ADDENDUM NO.1

FOR DESIGN/BUILD-FISH DOCK

WATERLINE AND HEAT TRACE SYSTEM REPLACEMENT
CITY OF HOMER, ALASKA

Addendum Issue Date: November 16, 2017

5) b.

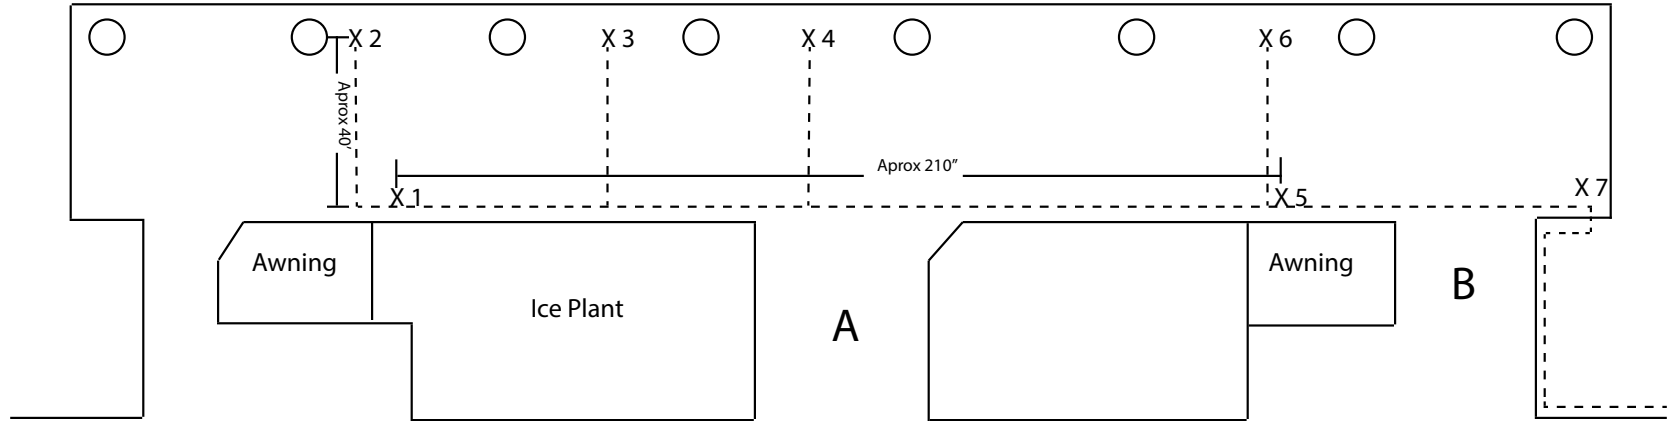
"X"s Mark faucet locations

Minimum Requirements: Have locations 1, 4, and 5 heat traced for winter operations while locations 2, 3, 6, and 7 are drained

Wish List: Have locations 2, 4, and 6, heat traced for winter operations while locations 1, 3, 5, and 7 are drained

- 220' of 2" HDPE pipe, insulated and heat traced. This pipe will exit the building and extend from location 1 (see following diagram) to location 5.
 - 85' of 1" HDPE pipe, insulated and heat traced. Approximately 65' of this pipe will run from the 2" insulated pipe to the faucet at location 4. The rest will drop down from the 2" insulated pipe to faucets at locations 1 & 5.

- 286' of 1" HDPE pipe, uninsulated. This pipe will run from the 2" insulated pipe to the faucets at locations 2, 3, 6, & 7. These pipes must be isolated with valves and drained during winter months.

Elevate water lines over the entrances to the dock to prevent impact from forklifts. This is most important at entrance "A" (see diagram).

Similar in scope to the Base Bid, but provides more heat-traced and insulated delivery options for vessels on the face of the dock. Uses approximately 218' of insulated and heat-traced 1" HDPE pipe (instead of 85' for the base bid). Per the provided diagram, have locations 2, 4, and 6, heat traced for winter operations while locations 1, 3, 5, and 7 are uninsulated and drained in winter. This configuration will use the same number of isolation and drain valves as the Base Bid and the 218' measurement assumes the 20' of insulated pipe used on the drops at locations 1 & 5 will now be used for the runs to locations 2 & 6.
